# WINDERMERE PRELIMINARY PLAN

PRELIMINARY  
LANDSCAPE  
EXHIBIT

**LS01**

# LS V\_4.pdf Markup Summary 2-3-2021

PLAYGROUND SITE PLAN  
1" = 40'

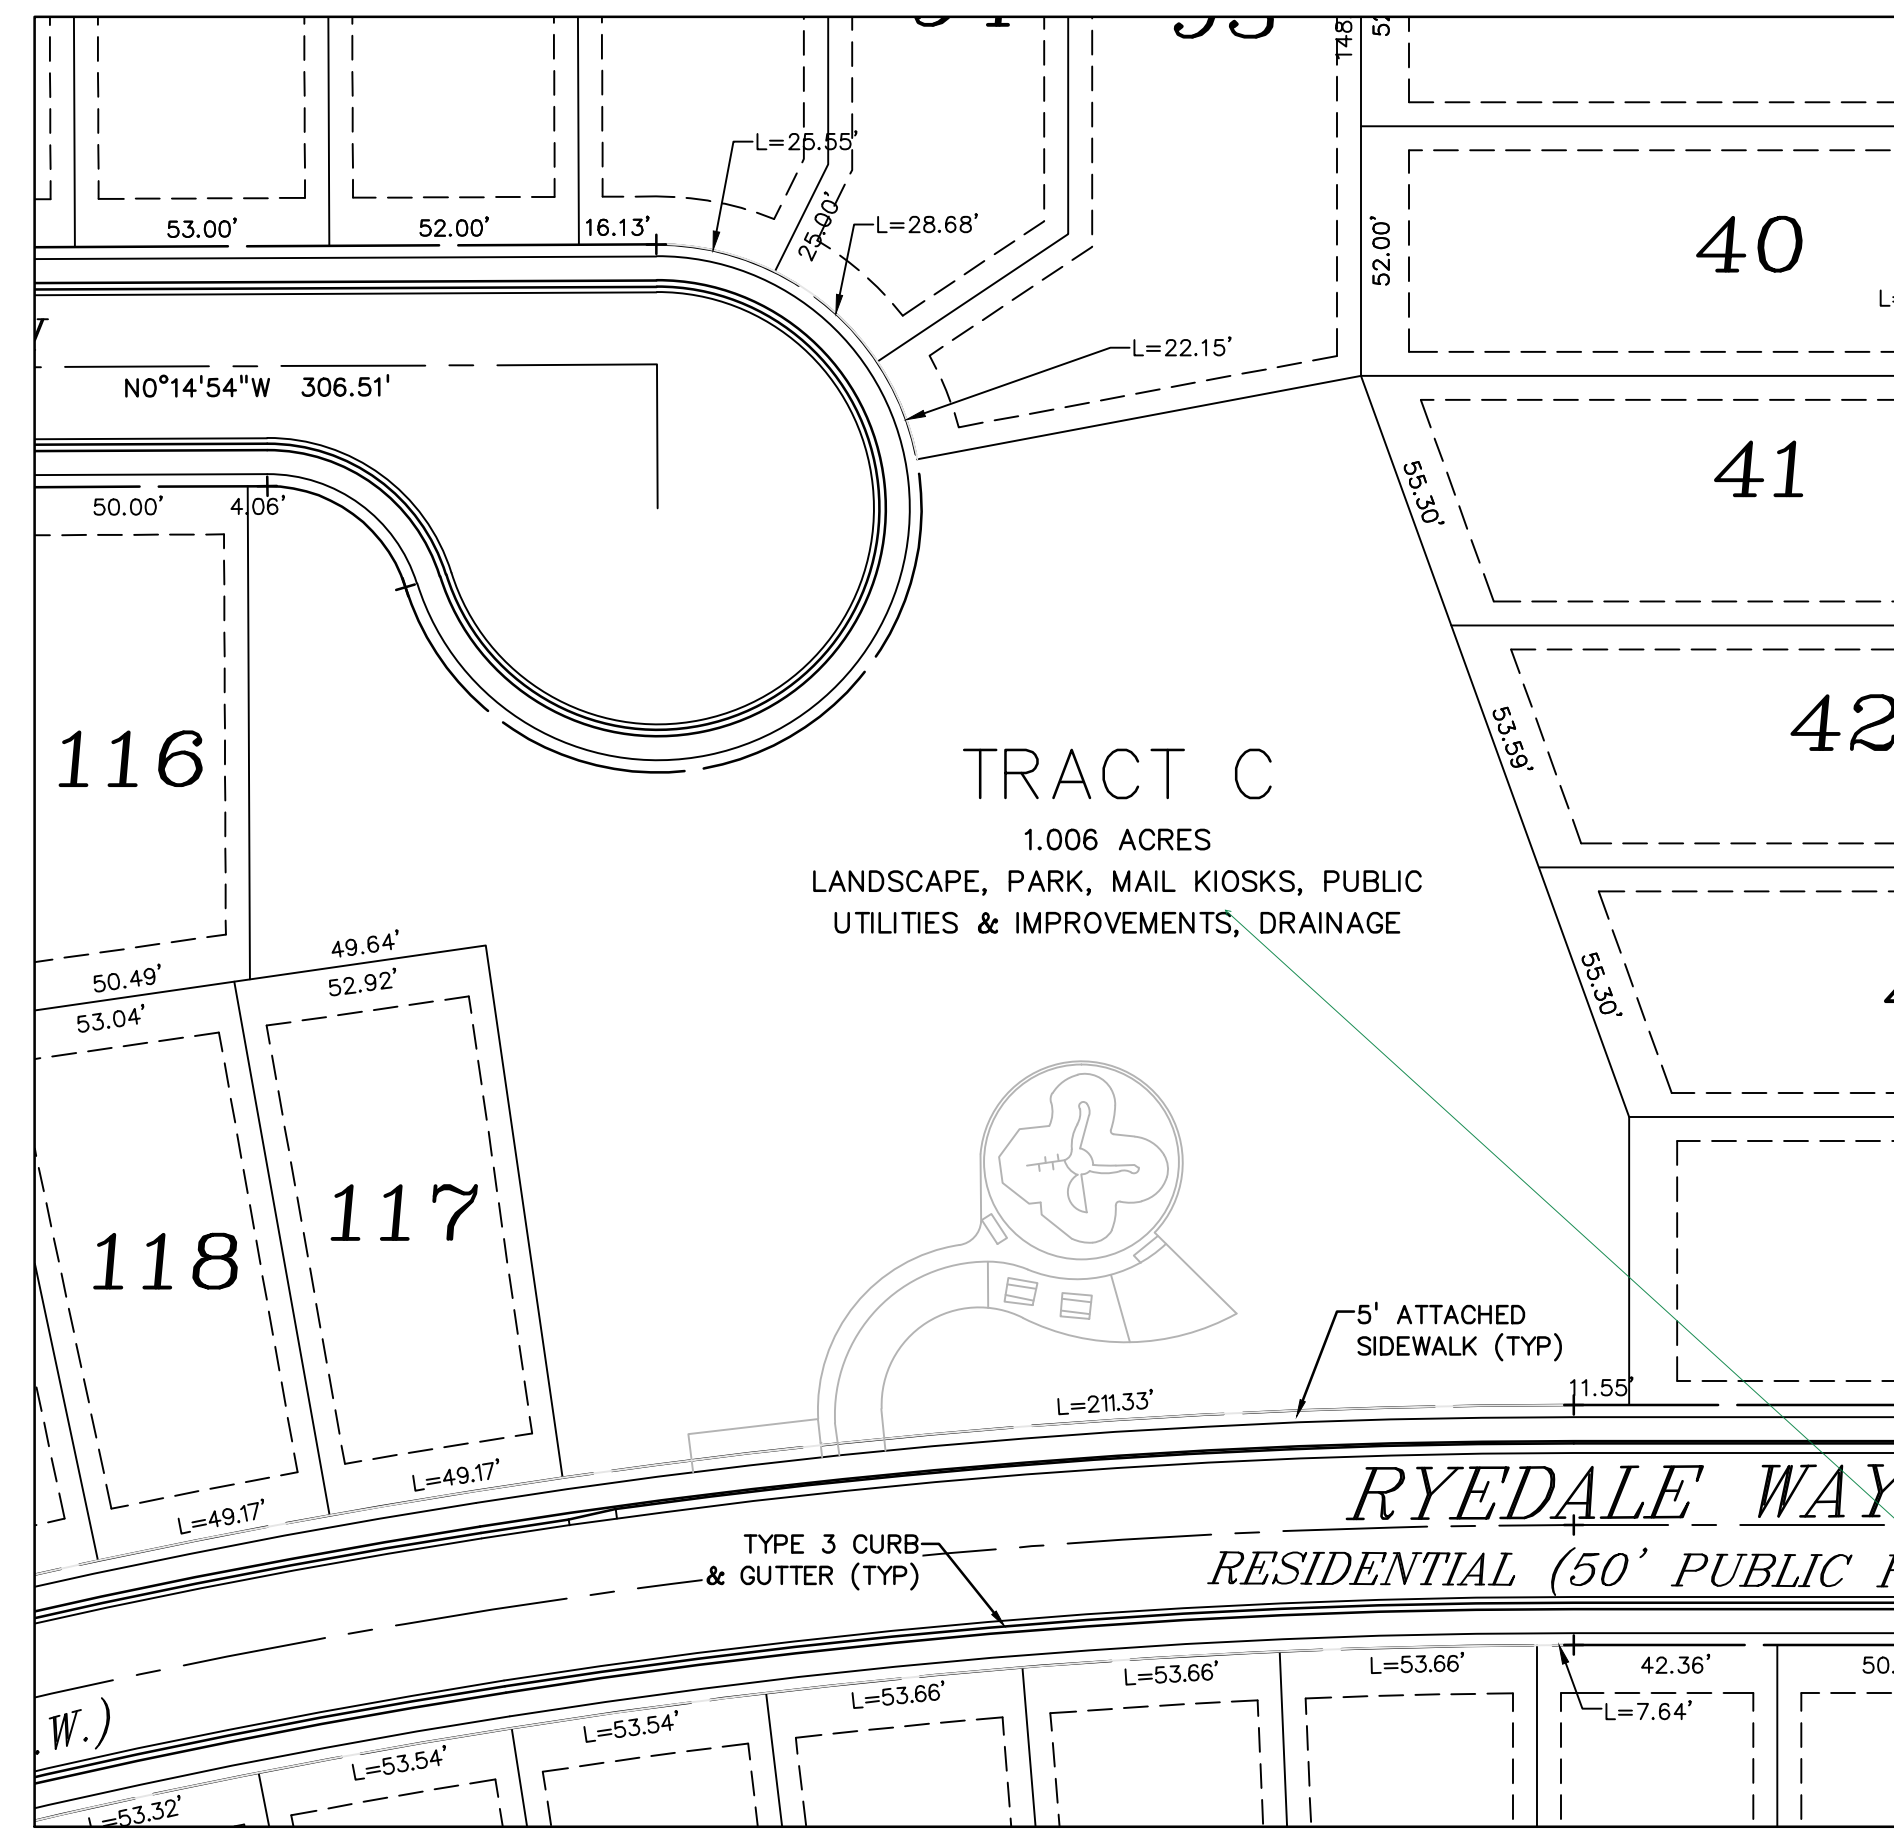
you can always use  
the plant species list  
and detail from  
Falcon Marketplace if  
your at a lost and in  
a hurry with a note  
plant species may  
change with final plat  
and final landscape  
plan.

LANDSCAPE BUFFER  
1" = 40'

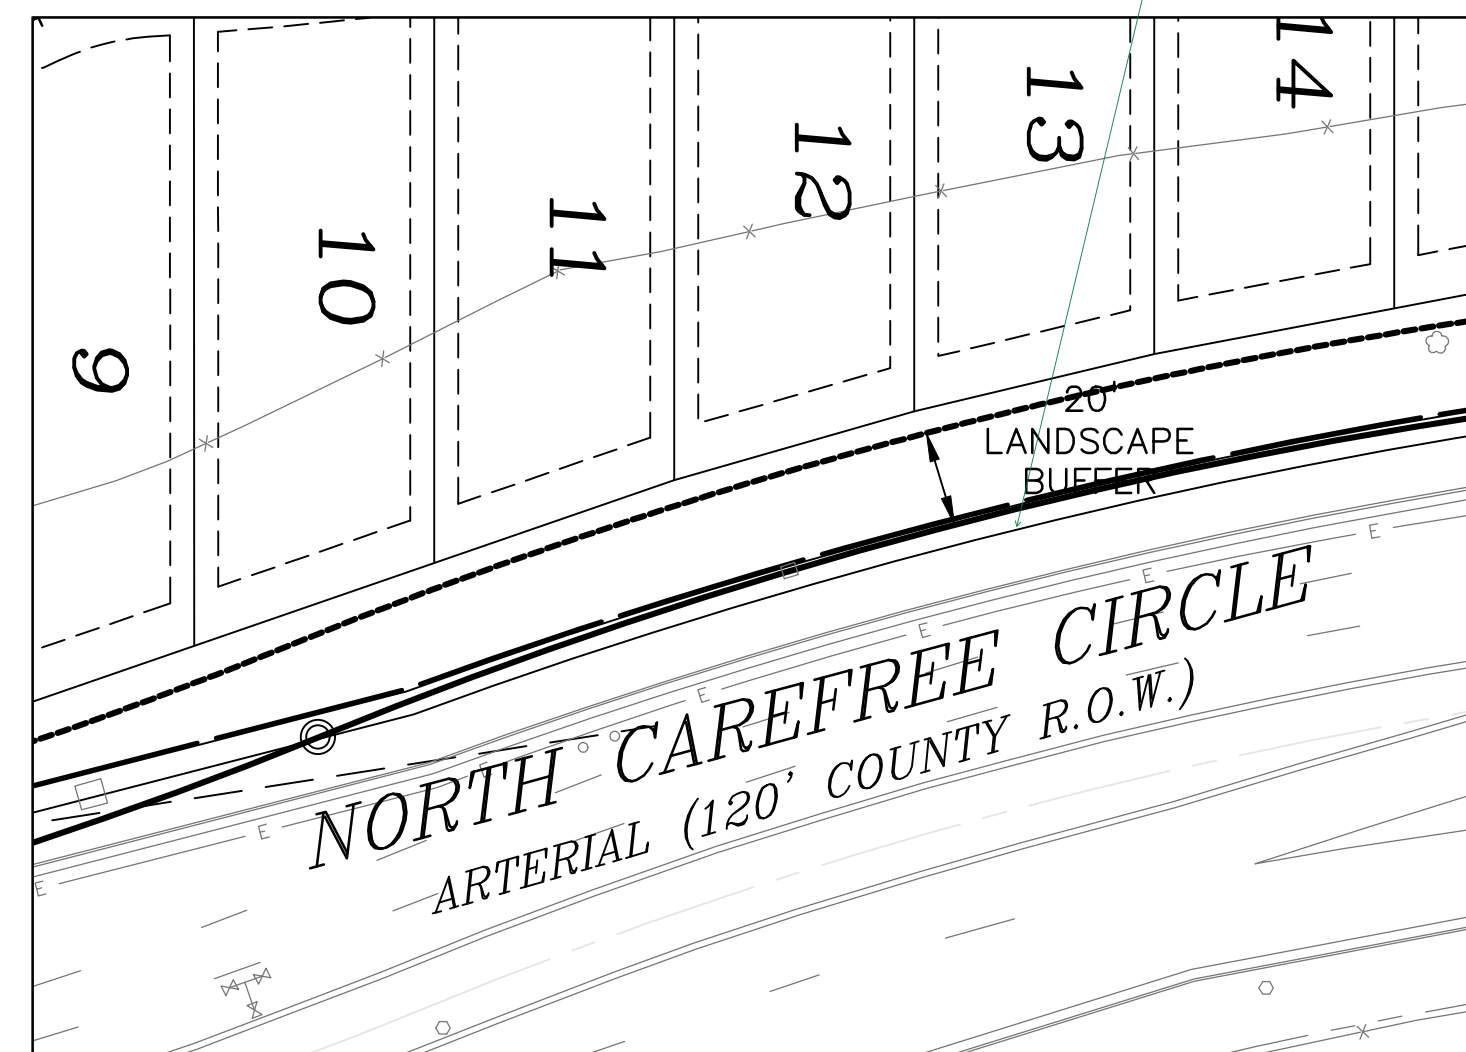
you will be very tight  
here due to electric  
lines; they wont let  
you place trees there  
so where will you put  
them? Between the  
sound barrier and lot  
line? You will need 6  
feet at least to plan  
B&B 2.5# caliper...  
Show-

add tree symbols and  
species

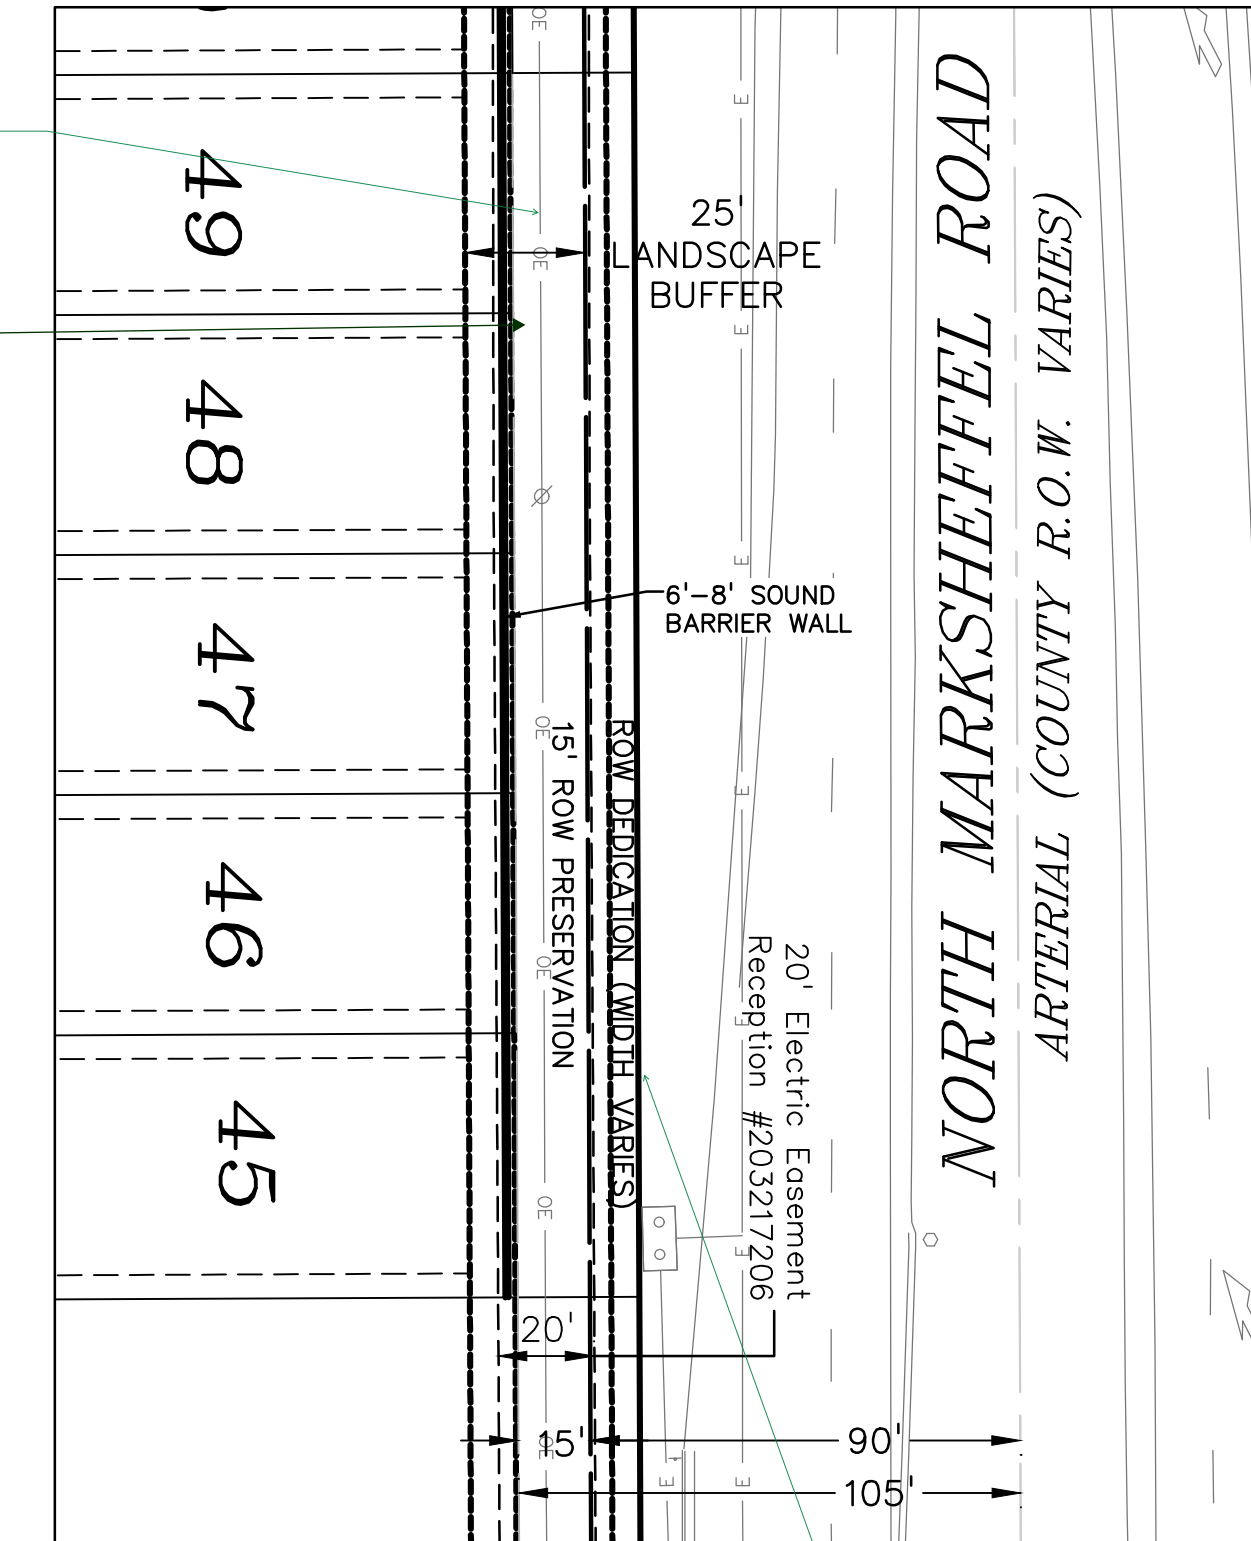
provide length of  
each linear footage  
and amount of trees  
required of those the  
evergreen required  
per table in Chapter  
6

any trees here?

enlarge details so we  
can see plants
